EXPLANATION OF SIGNIFICANT DIFFERENCES #2
BALLY GROUND WATER CONTAMINATION SUPERFUND SITE
BALLY, BERKS COUNTY, PA

In summary, this ESD changes the discharge location of Municipal Well Number Three (MW#3) from an unnamed tributary of the West Branch of the Perkiomen Creek, to the West Branch of the Perkiomen Creek itself.

Figure 2

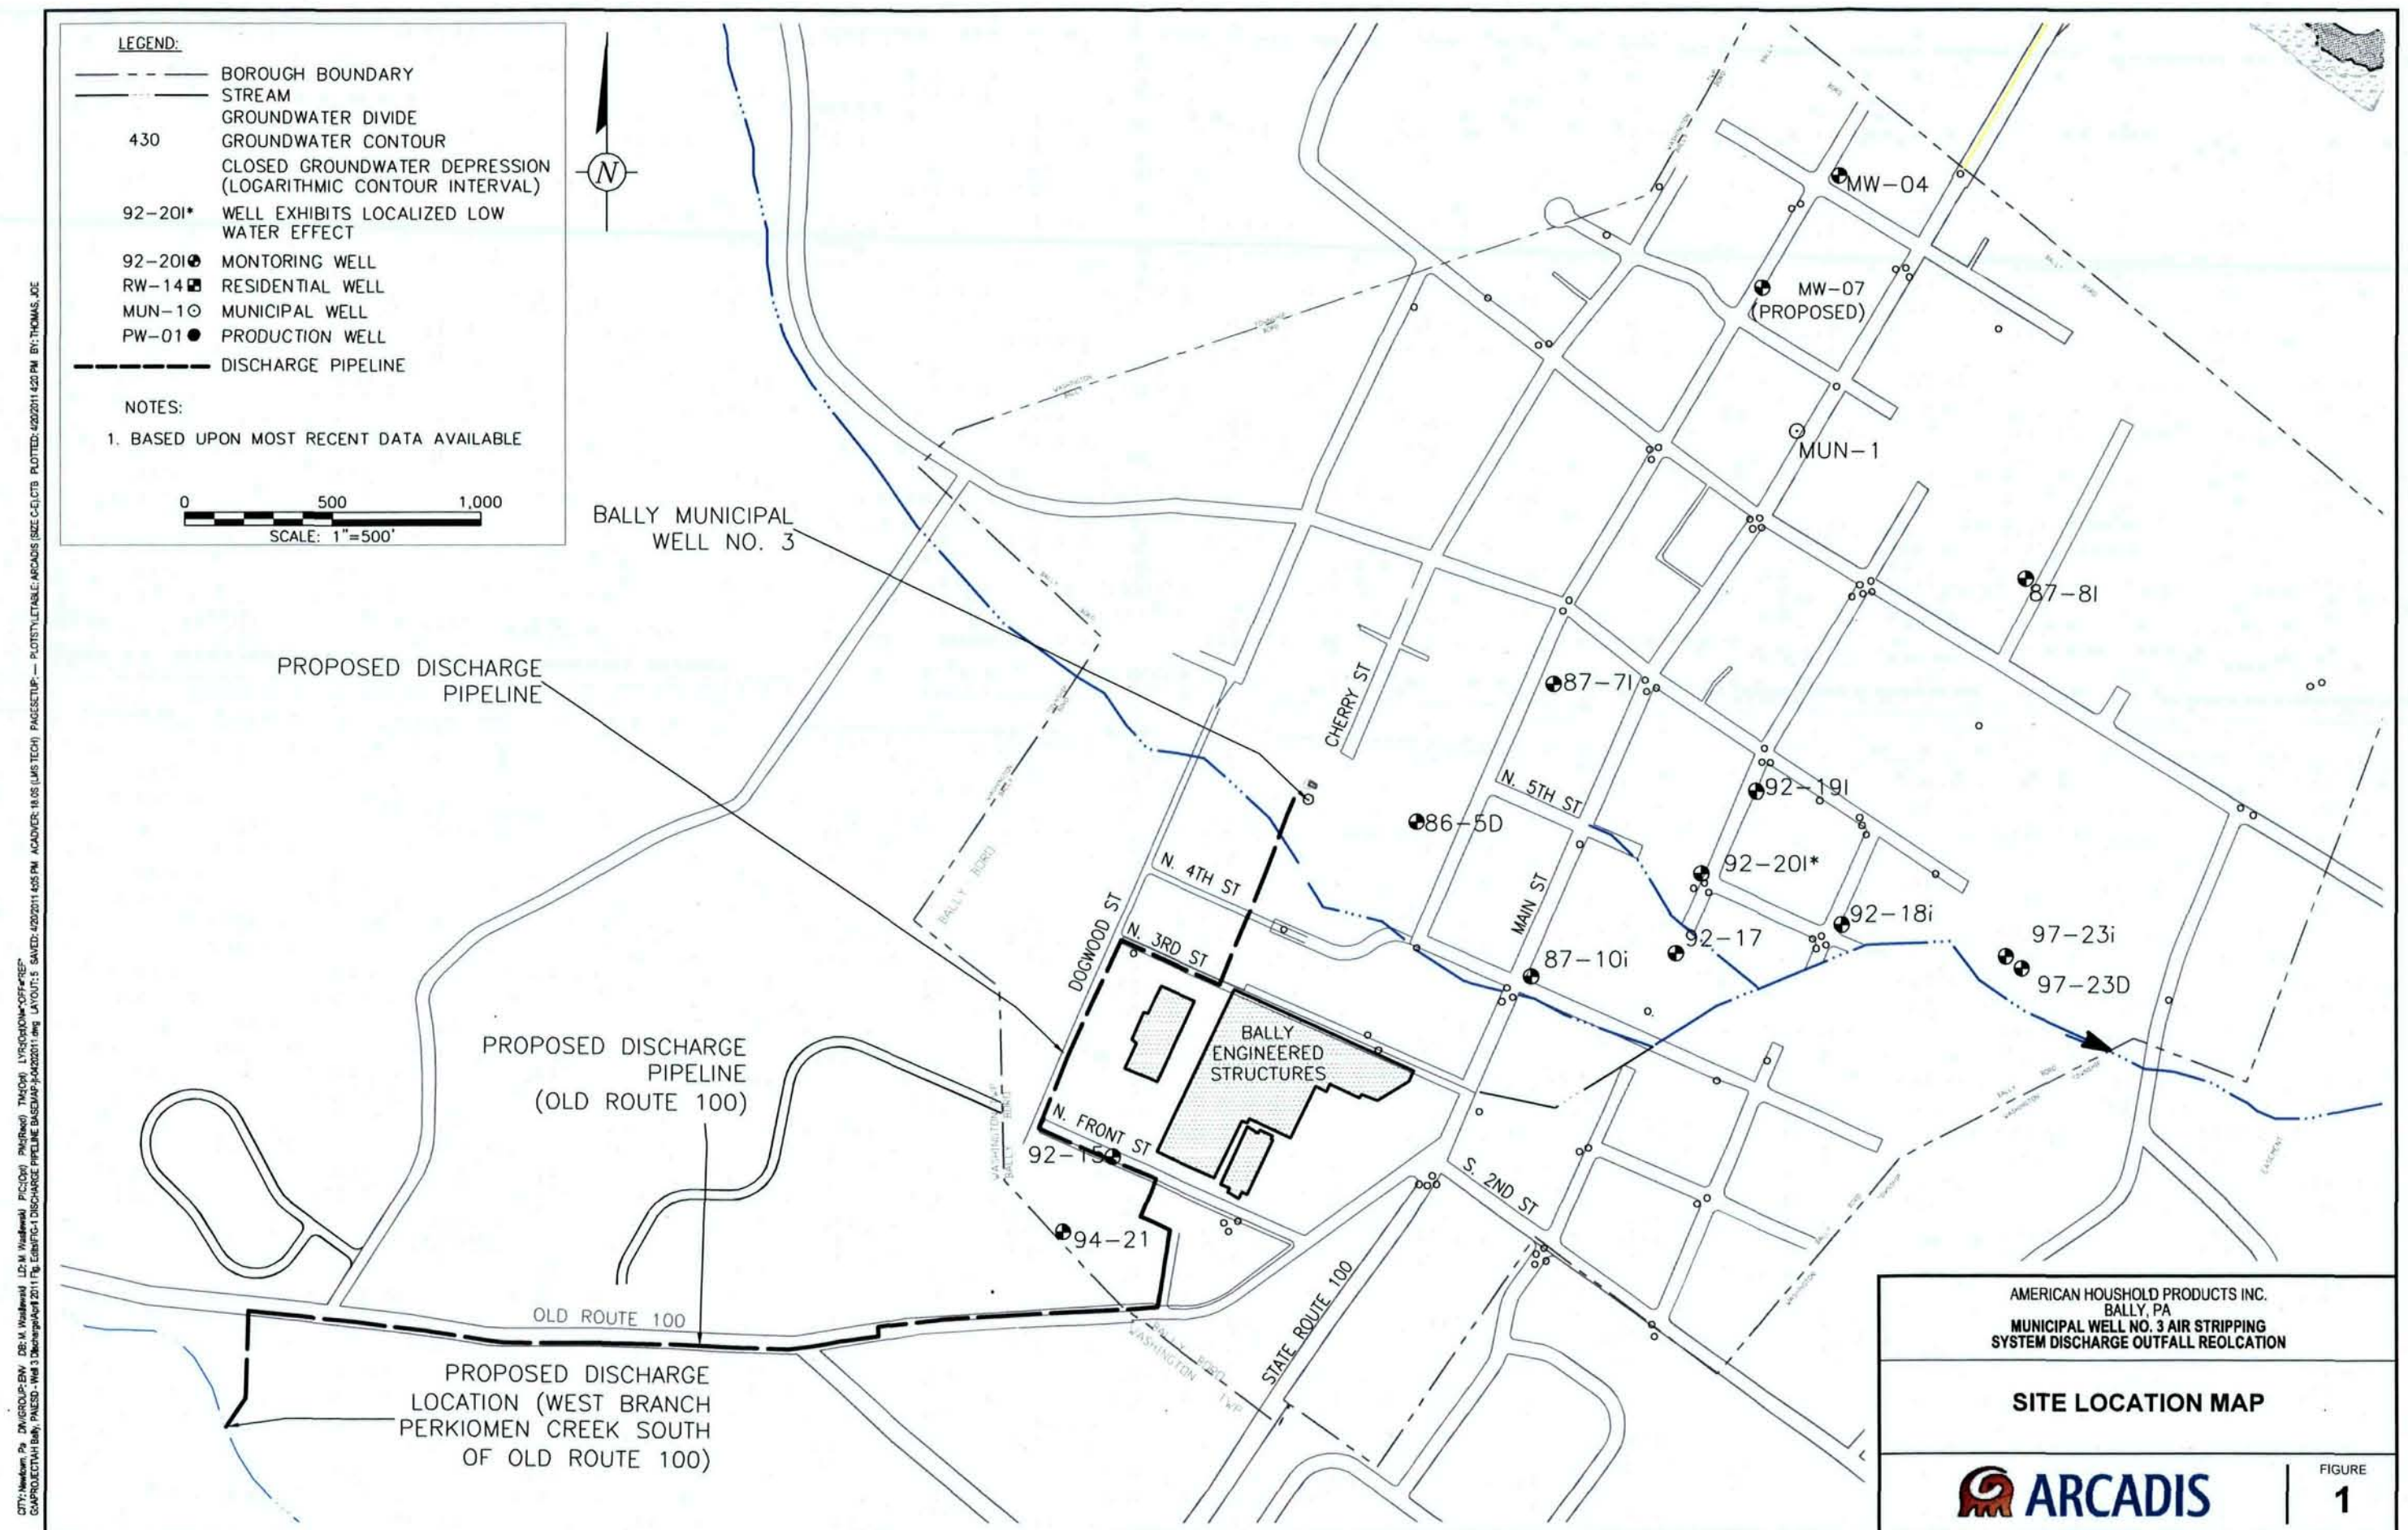
The most contaminated portion of the ground water contamination plume lies between the Facility and MW#3. The remainder of the plume extends to the southeast, generally following topography and a stream valley formed by unnamed tributaries of the West Branch of the Perkiomen Creek (West Branch). See Figure 2.
